ADDENDUM NO. 03

PROJECT: Ossining Union Free School District
2024 Bond: Phase 1
OHS Locker Room & CTE Addition

CPL PROJECT NO. R24.16761.00

DATE: May 21, 2026

Drawing Number: HS H500

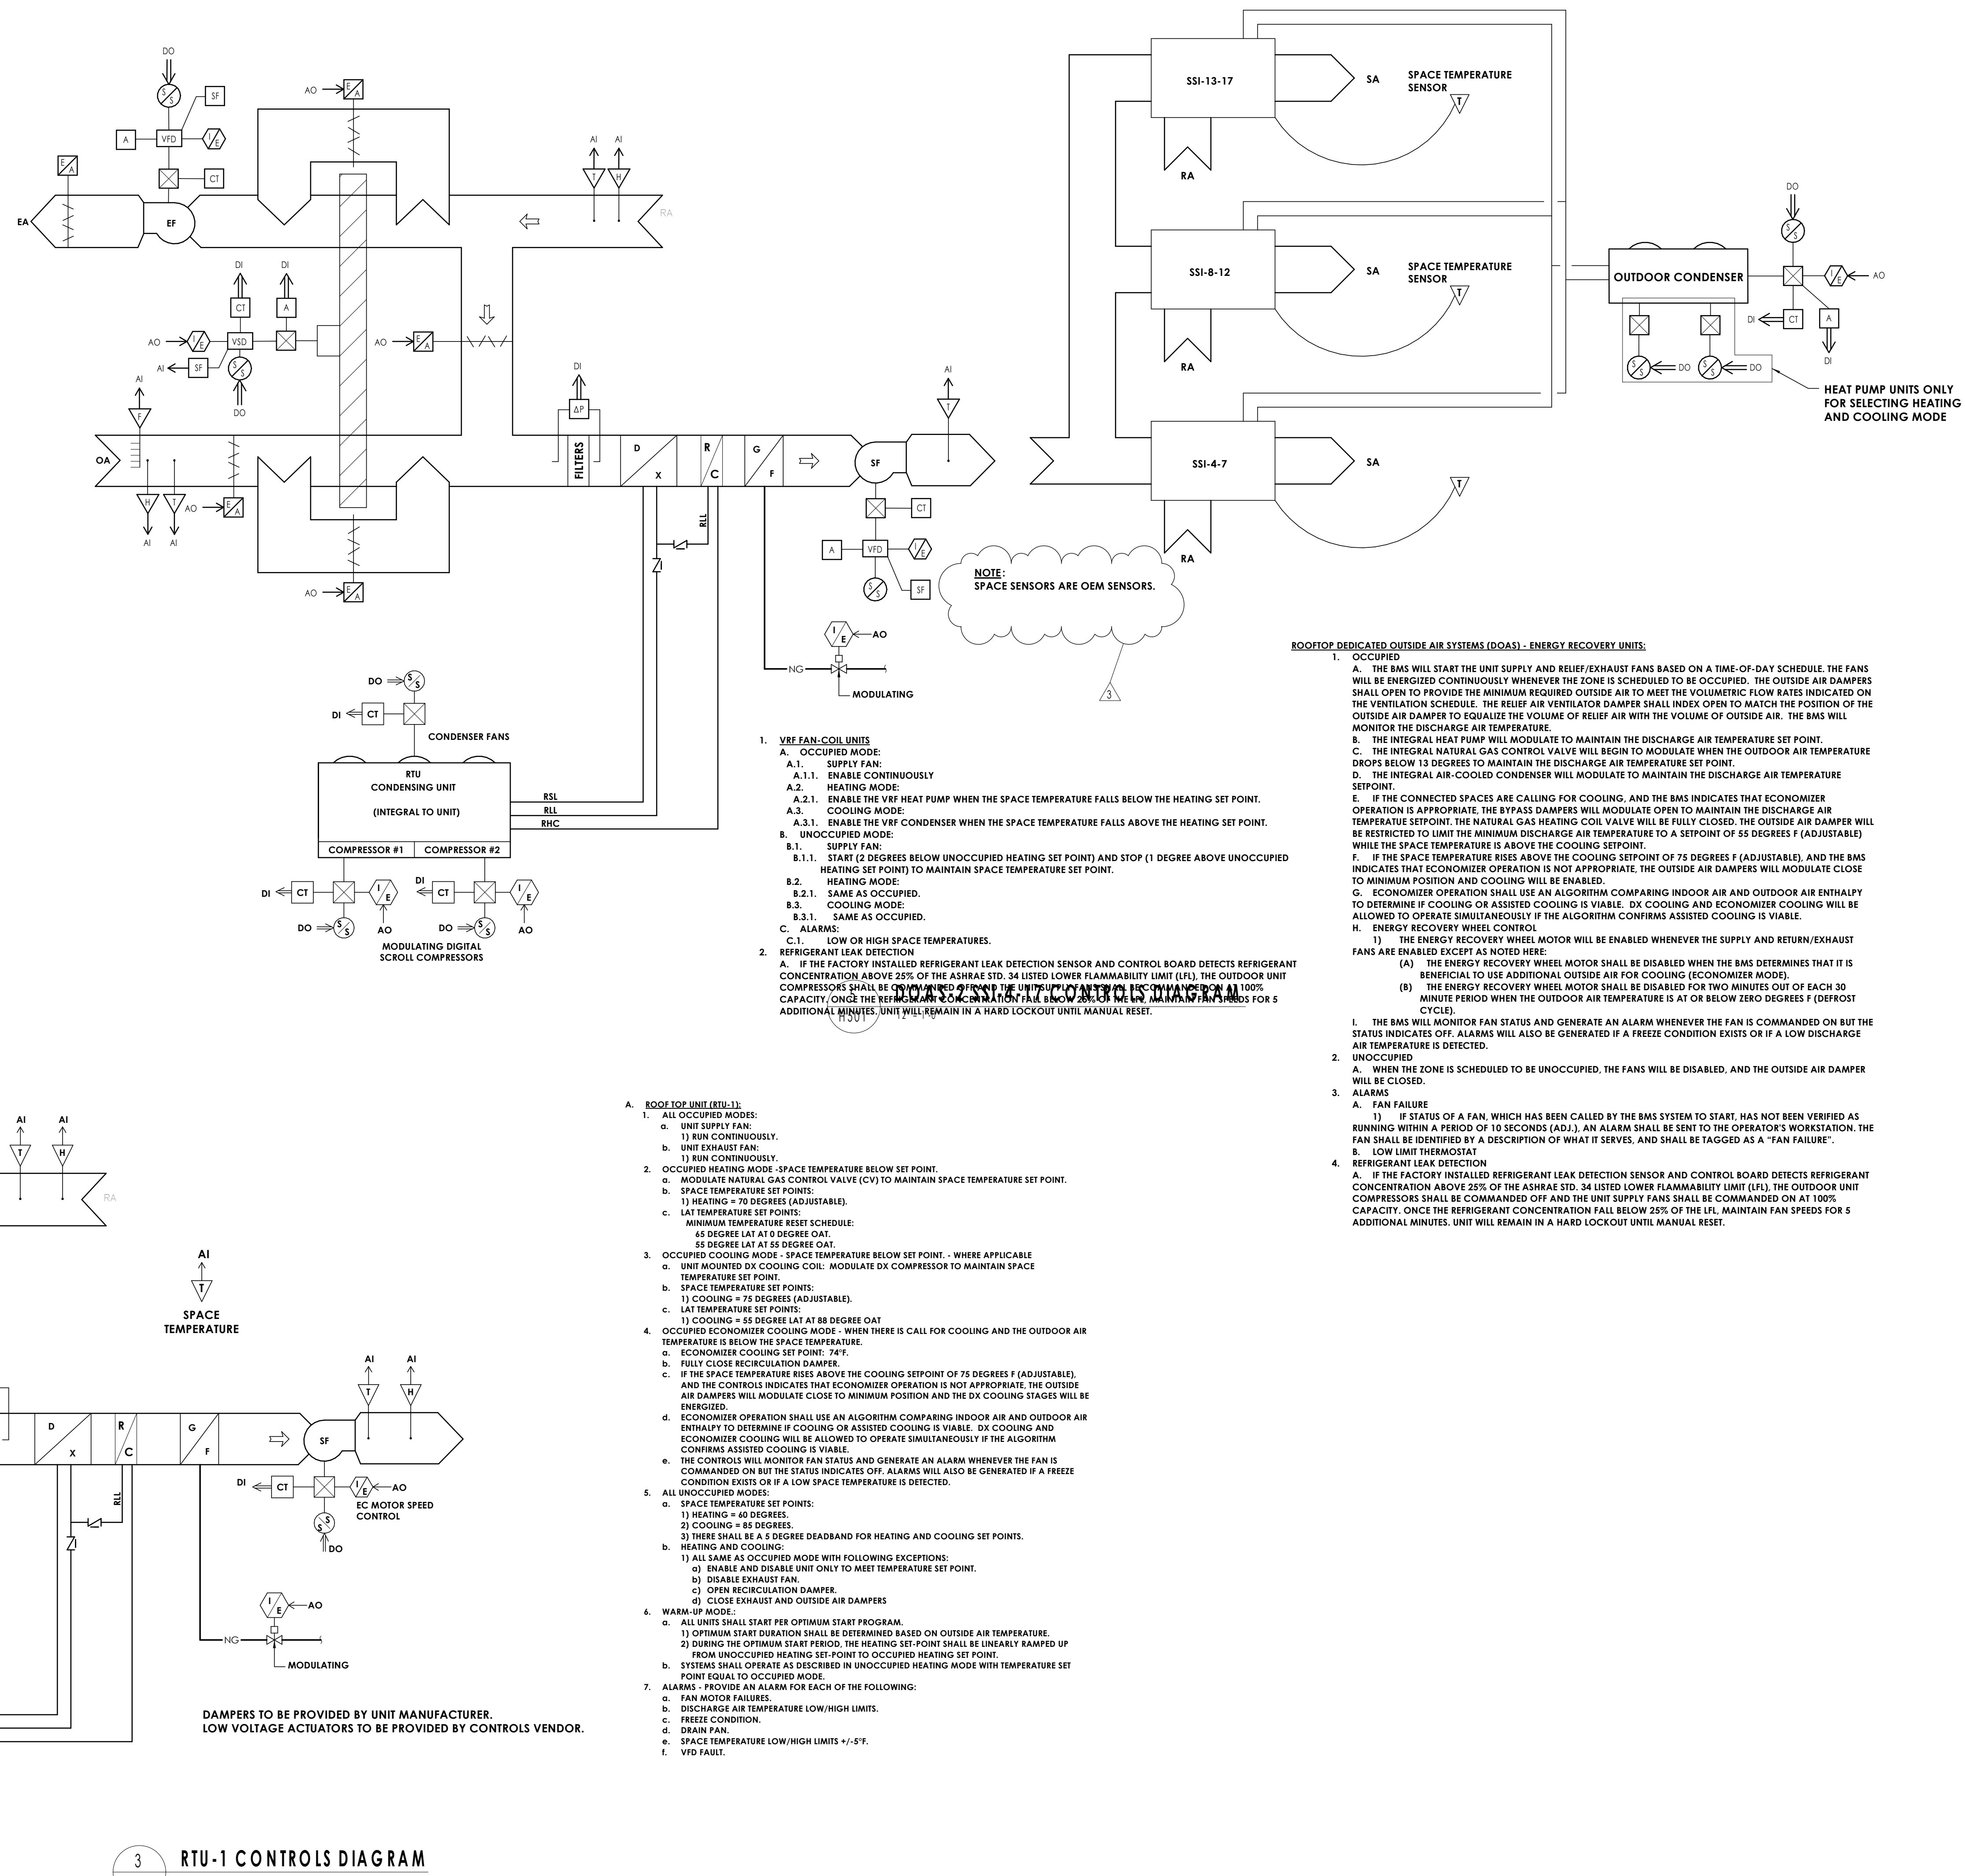
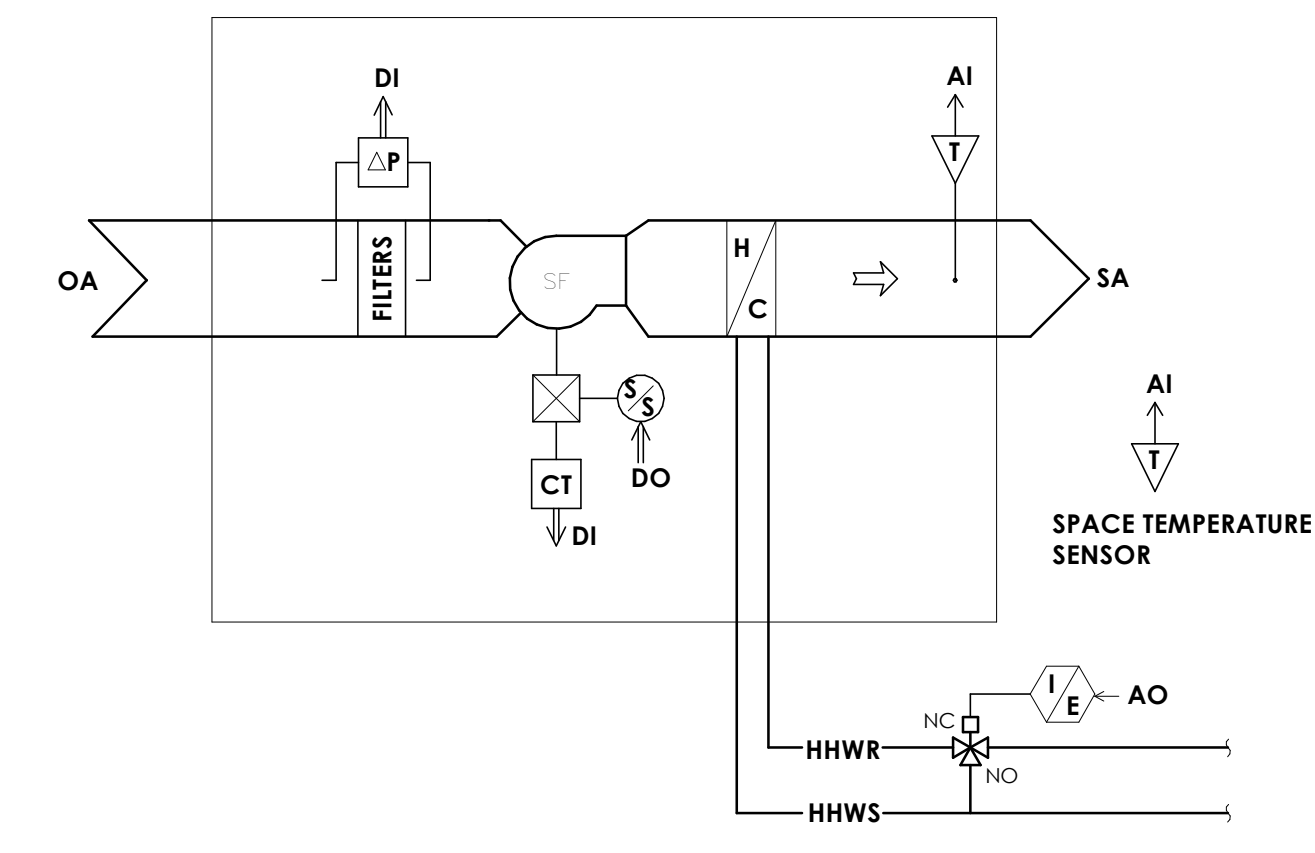
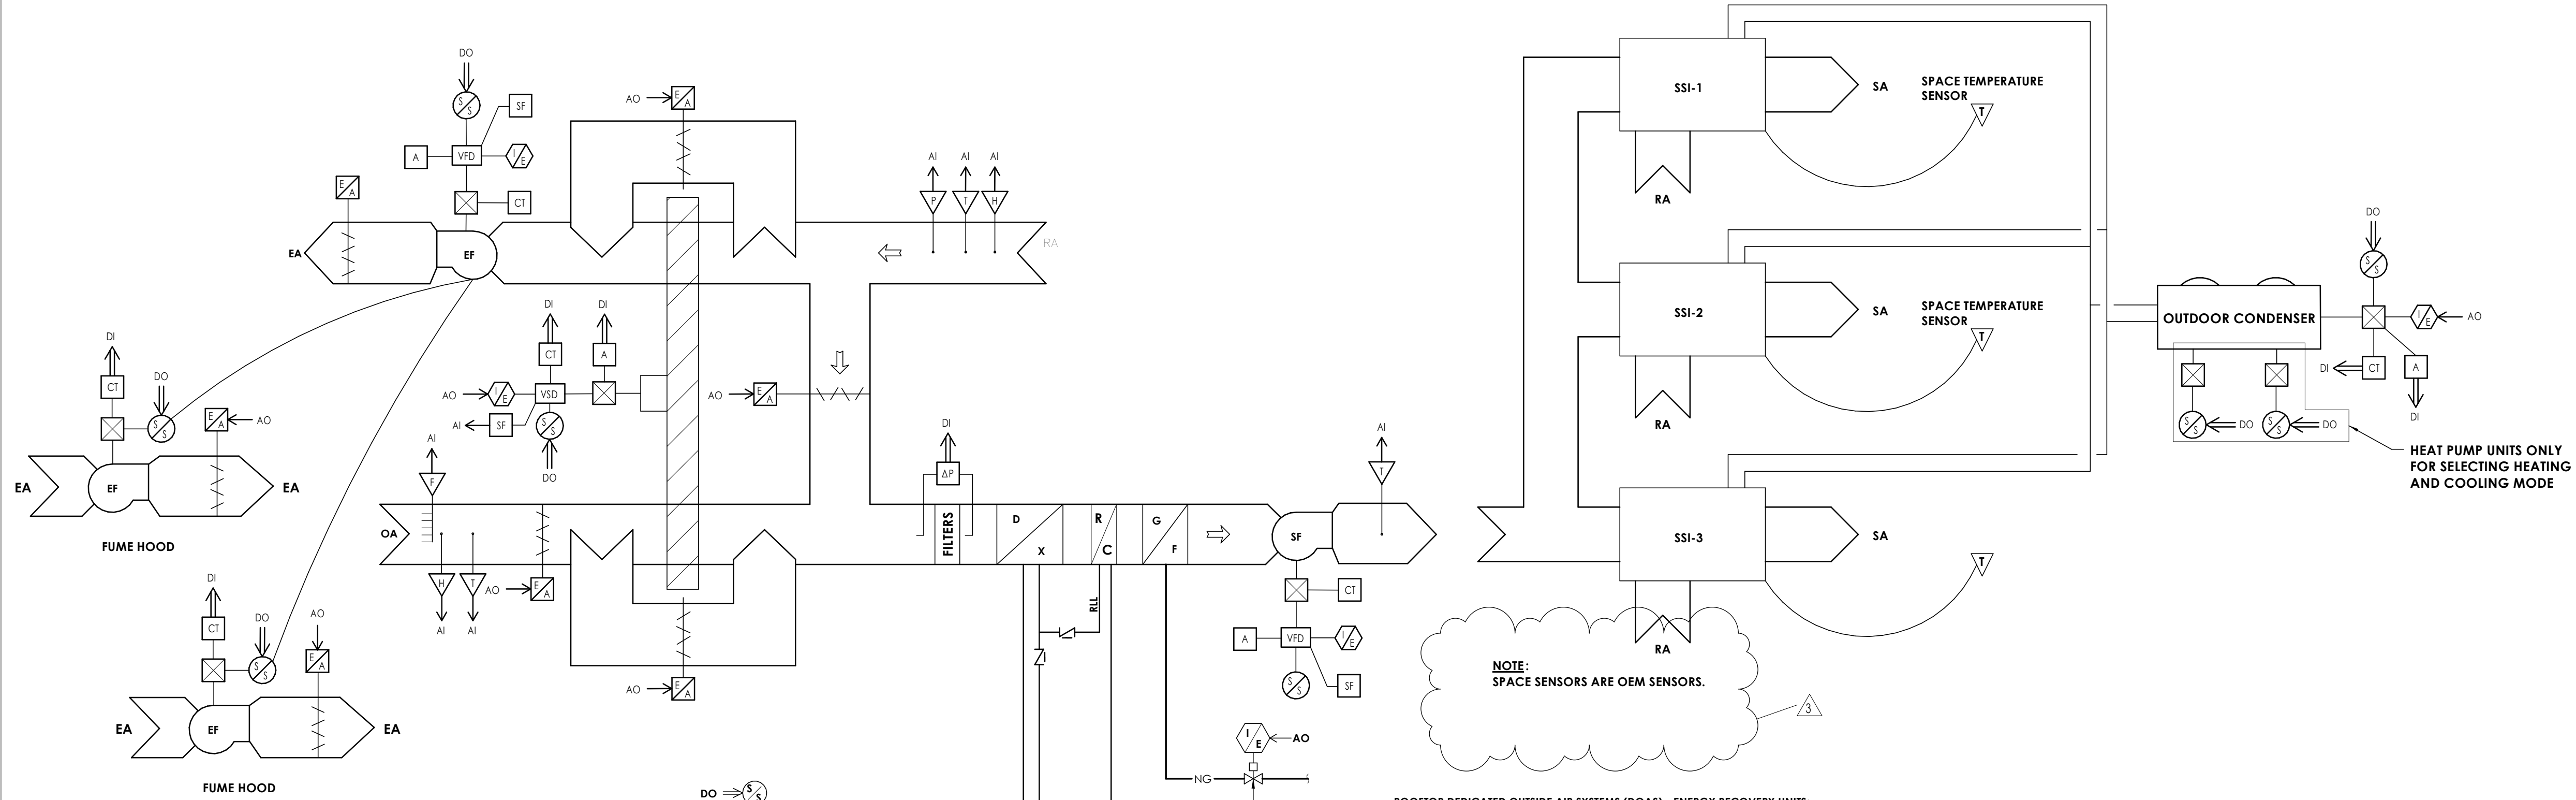
1.33 Question: Drawing H500 Detail 3 and Drawing H501 Detail 5 calls for equipment to have Bacnet cards for future connectivity. Please confirm this is desired and advise which equipment this applies to. Please also advise if any other equipment is to receive Bacnet cards for future connectivity.

1.43 Question: Please advise if a refrigerant monitoring system is required for the VRF systems. If so please provide a desired spec.

Answer: All equipment shall have Bacnet capabilities and be tied into existing BMS during this project.

Answer: See revised H500 drawing for refrigerant leak detection sequence.
